LIST OF FIELD MODIFICATIONS

AIRCRAFT GENERAL

(This EO replaces EO 05-1-6A dated 15 Mar 62)

Figure 1

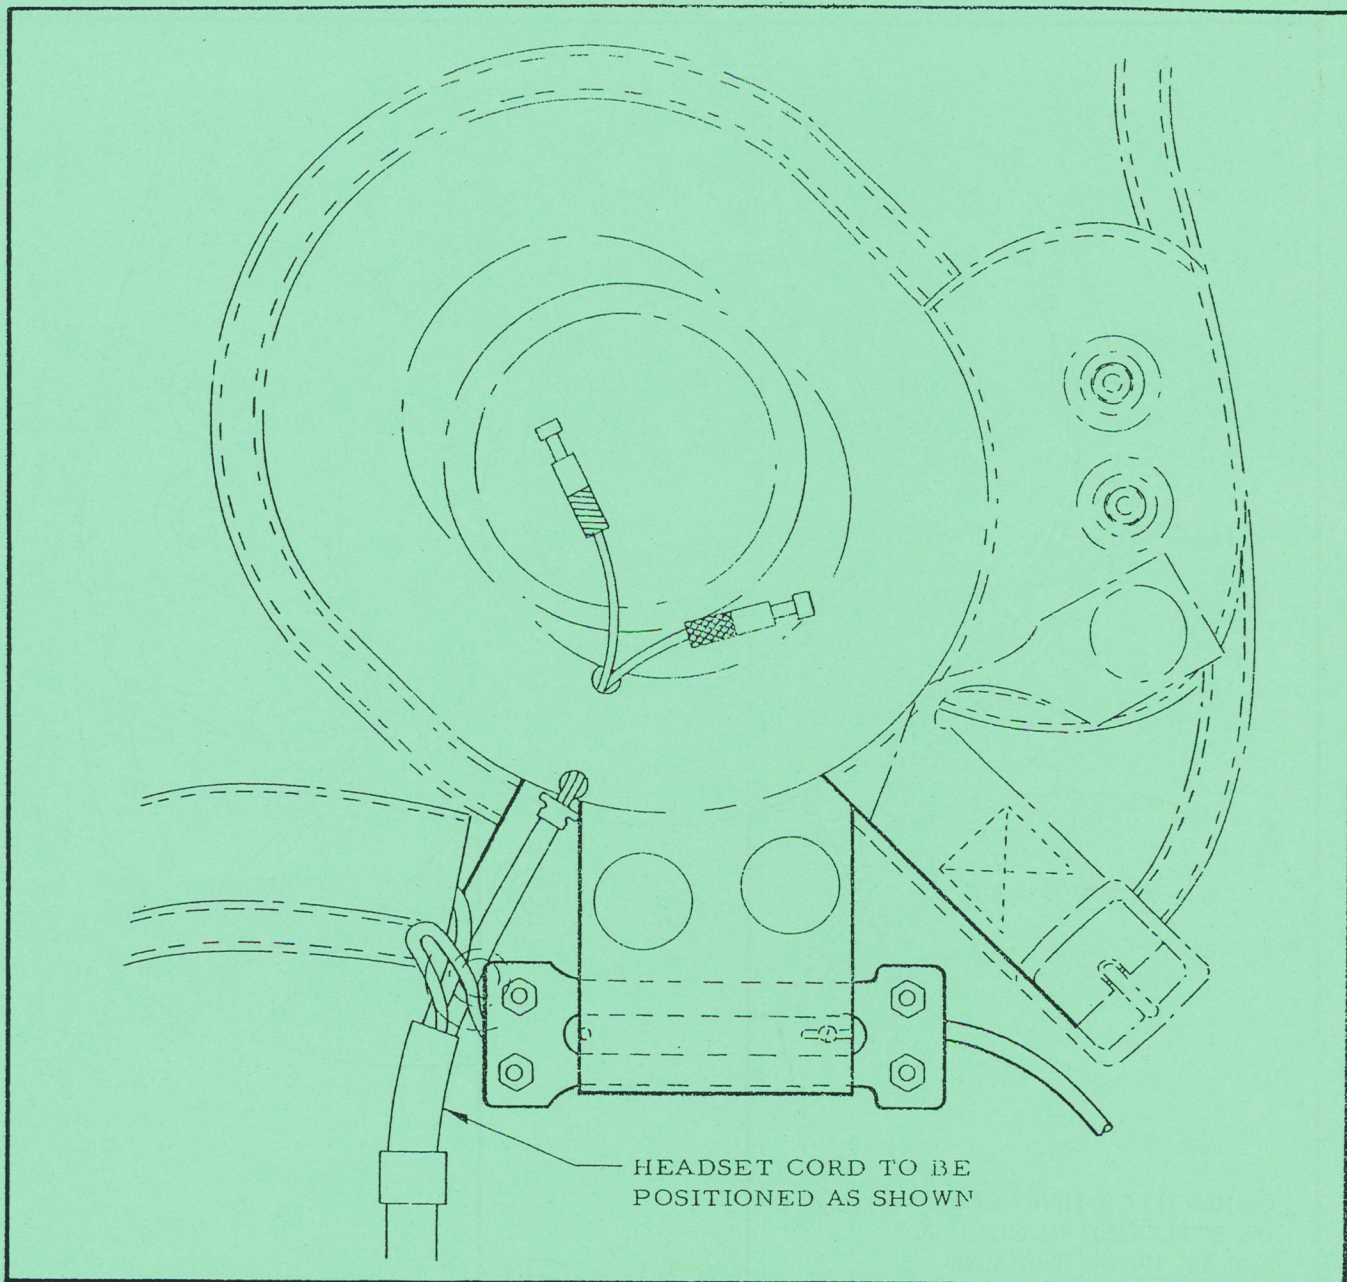
- (a) Remove the two receivers Ref. 10EC/27819 from the helmet.
- (b) Remove headset cords Ref. 10EA/29525 and 10EA/29526 from the helmet.
- (c) Stitch the microphone connector harness to the helmet as shown in Figure 1, using thread nylon Ref. 32P/415.
- (d) From the new cord assembly Ref. 10EA/56726 remove the cross bar strain reliefs at the end of receiver cables. Retain the cross bars.

CONNECTOR HARNESS TO
BE STITCHED IN POSITION
SHOWN USING THREAD
NYLON REF. 32P/415

Figure 2

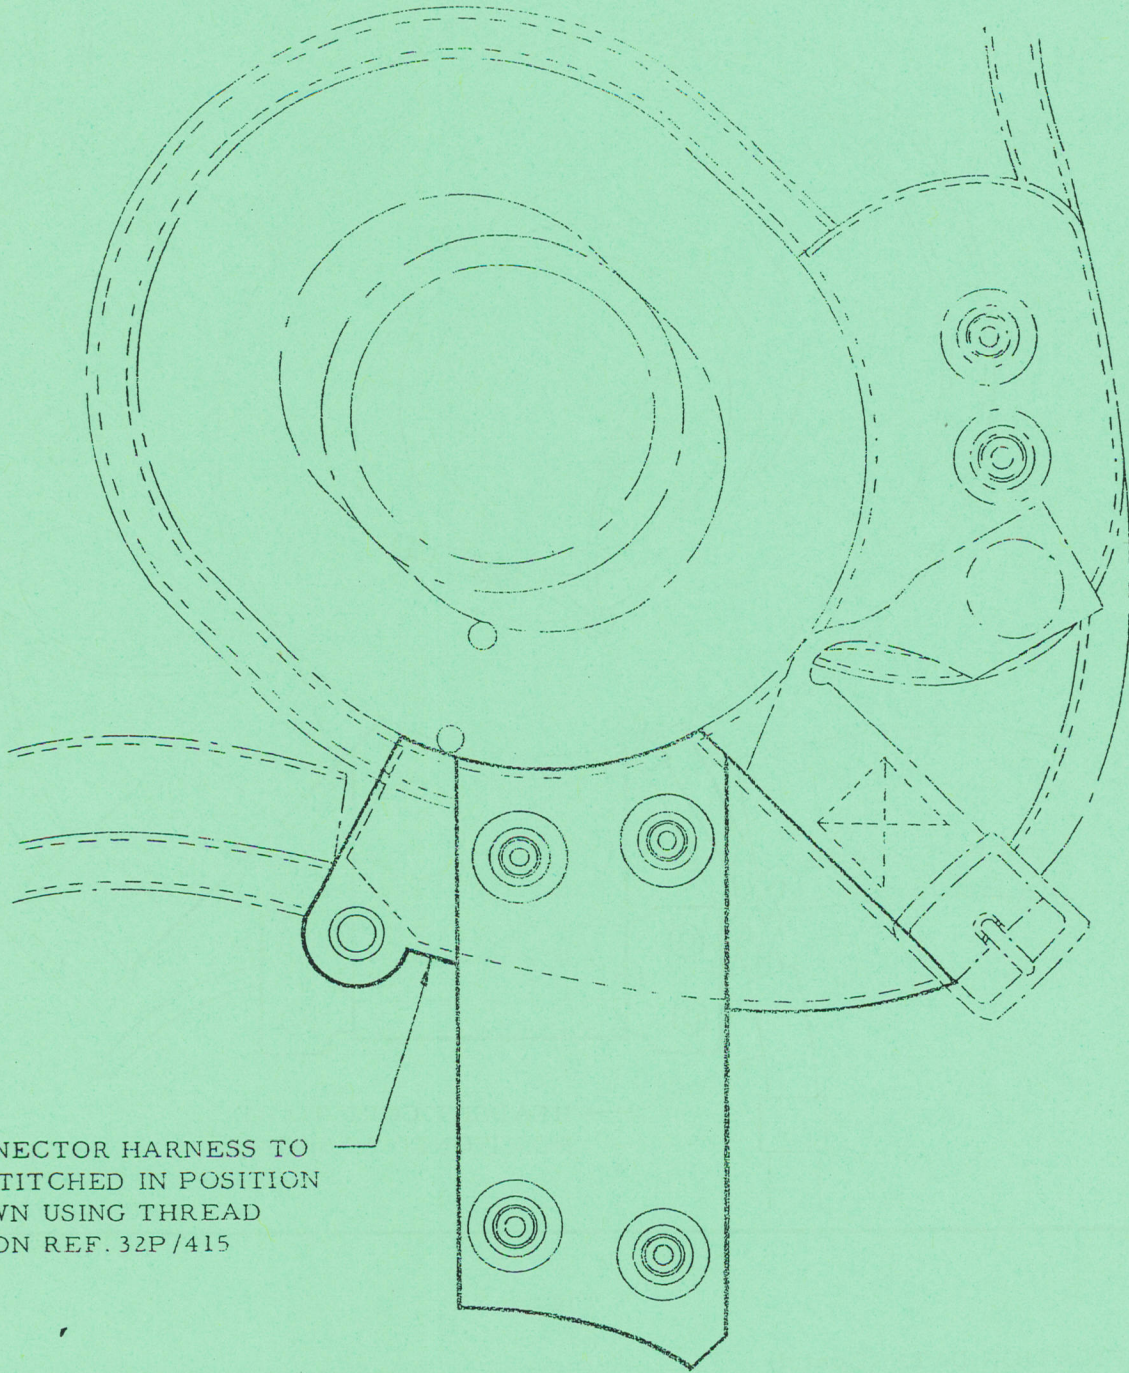
- (e) Insert the longer receiver cable through the channel across the back of the helmet, from right to left, refer to Figure 2.
- (f) Feed the receiver cables through the holes in the rubber earpieces and replace the cross bar strain reliefs removed in para. 2(d).
- (g) Insert the receiver leads in the receiver sockets and tighten the securing screws on the side of the receivers.

Figure 4

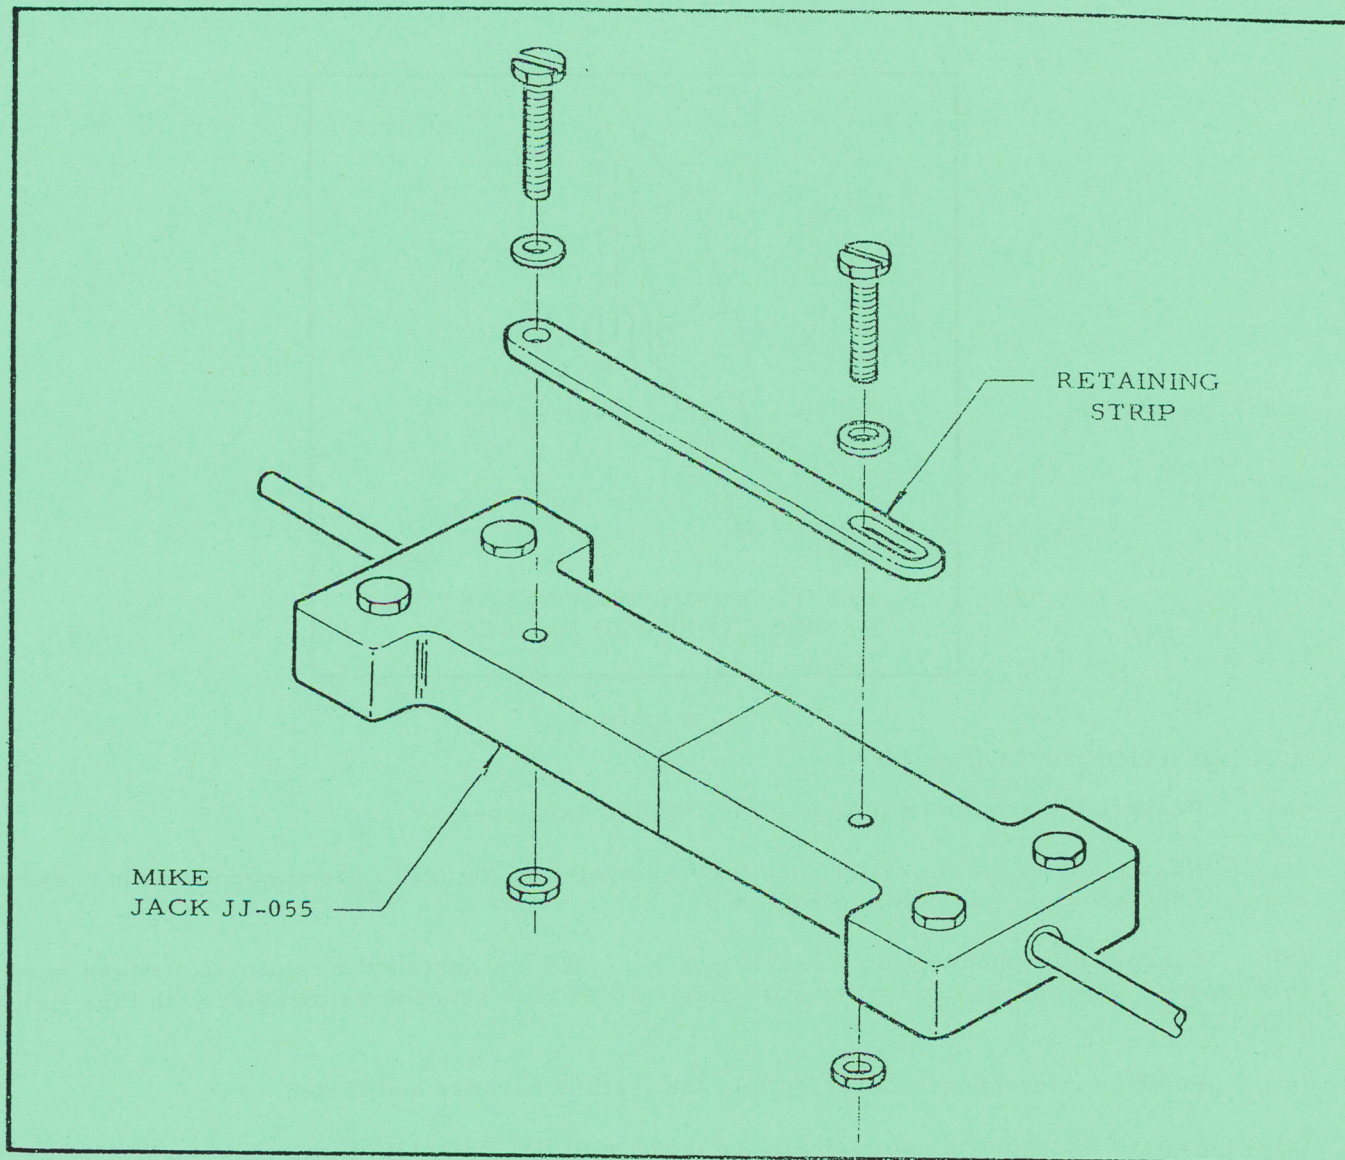
- (h) Replace the receivers in the helmet rubber earpieces.
- (j) Pass the cord strain relief hook through eyelet on the microphone connector harness and bend the hook closed; refer to Figure 3.
- (k) Connect microphone plug PJ-292 to jack JJ-055 and install the retaining strip as shown in Figure 4. Microphone cord fitted with plug PJ-291 tape connectors together with tape Ref. 33G/135.
- (m) Position microphone connector into the leather harness and fasten.
- (n) Excess microphone cable should be taped with Ref. 33G/135 Tape, polyvinyl chloride.
- (p) Check the helmet.

Figure 5

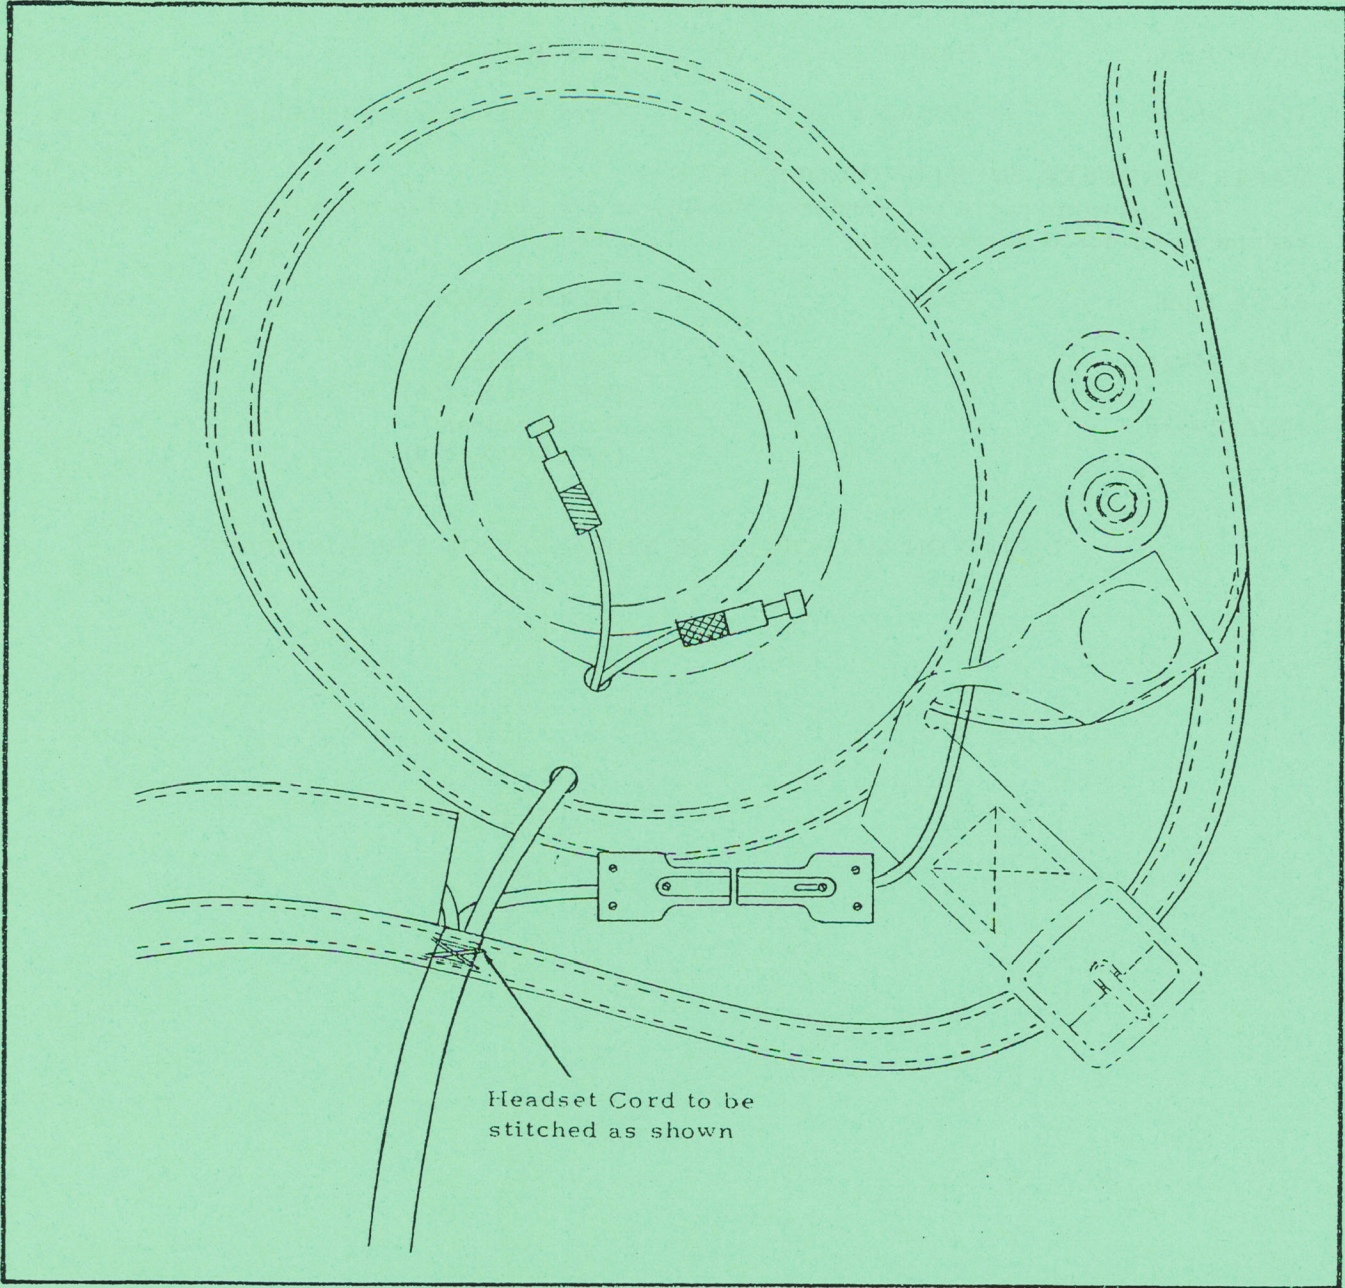
- (v) Insert the receiver leads in the receiver sockets and tighten the securing screws on the side of the receivers.
- (w) Replace receivers in the helmet rubber earpieces.
- (x) Stitch headset cord to the helmet as shown in Figure 5.
- (y) Remove and discard strain relief assembly shown in Figure 3 from headset cord.
- (z) Connect microphone PJ-292 to jack JJ-055 and install retaining strip as shown in Figure 4. Microphone cord fitted with plug PJ-291 tape connectors together with tape Ref. 33G/135.
- (aa) Excess microphone cable should be taped with Ref. 33G/135 tape, polyvinyl chloride.
- (ab) Check helmet.

Figure 1

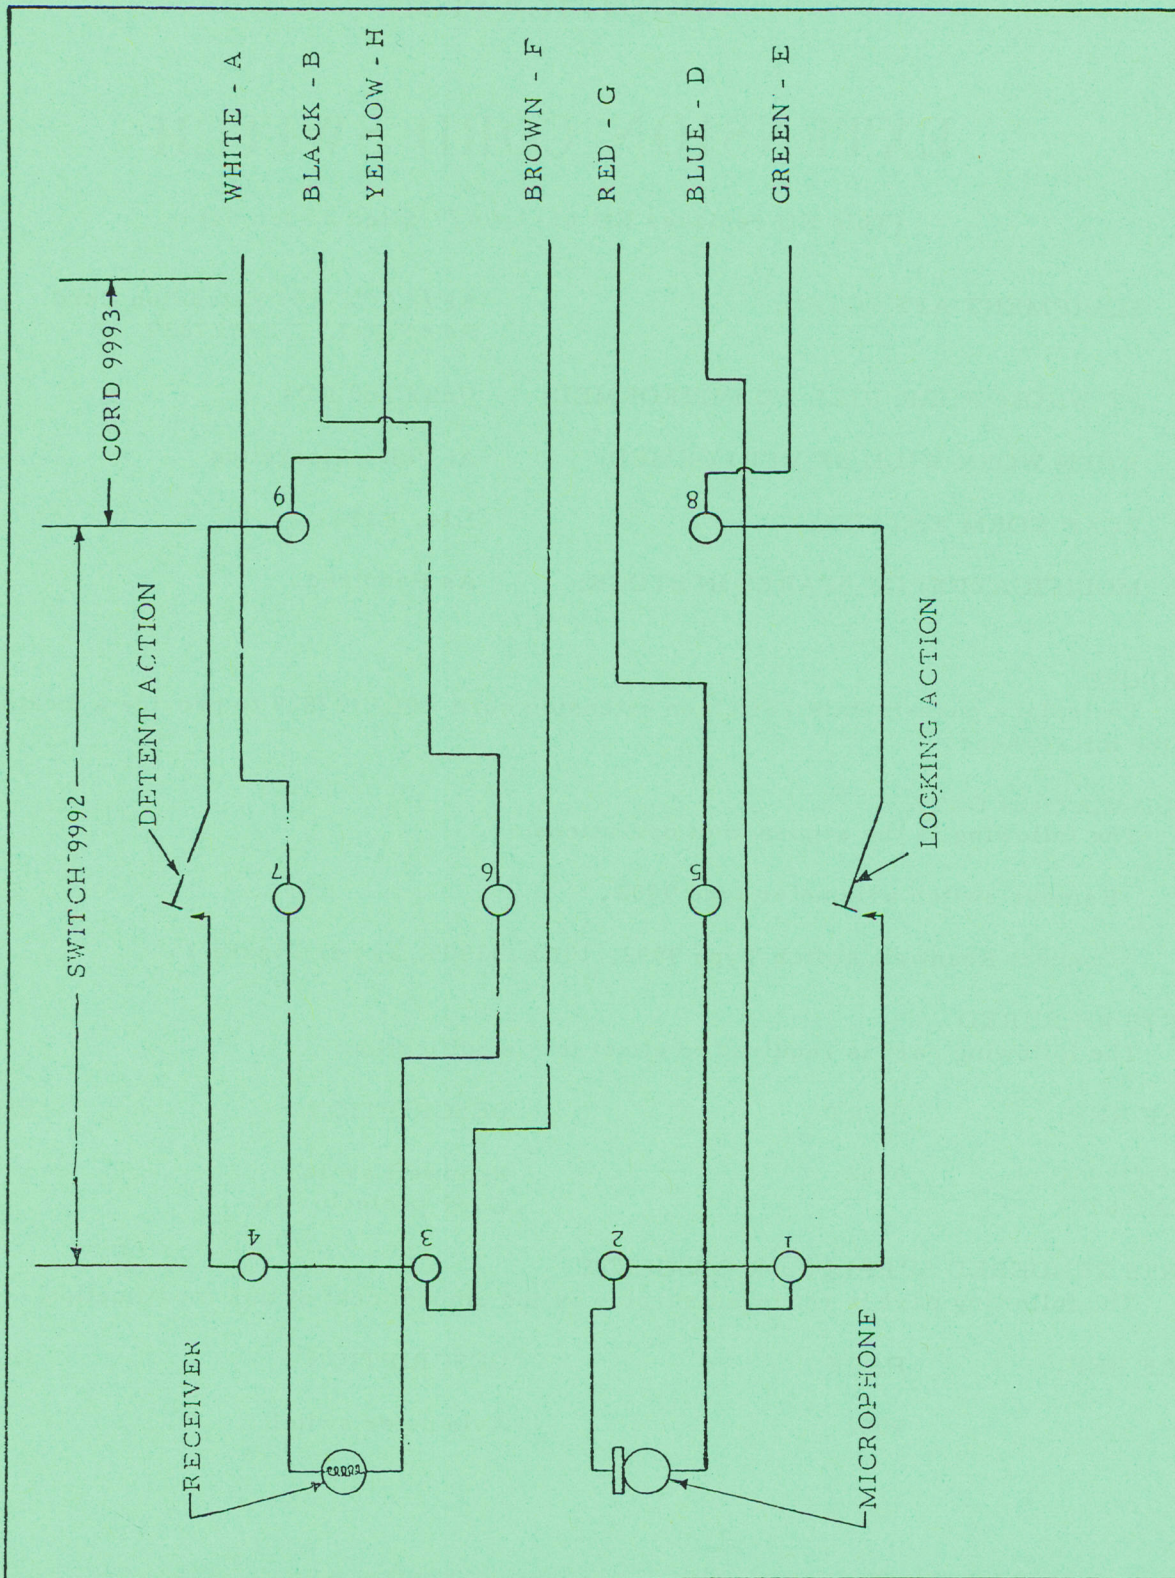
- (a) Remove switch aviometer type 9002.
- (b) Connect Roanwell switch Type 9992, 10EA/33905, as per Figure 1.
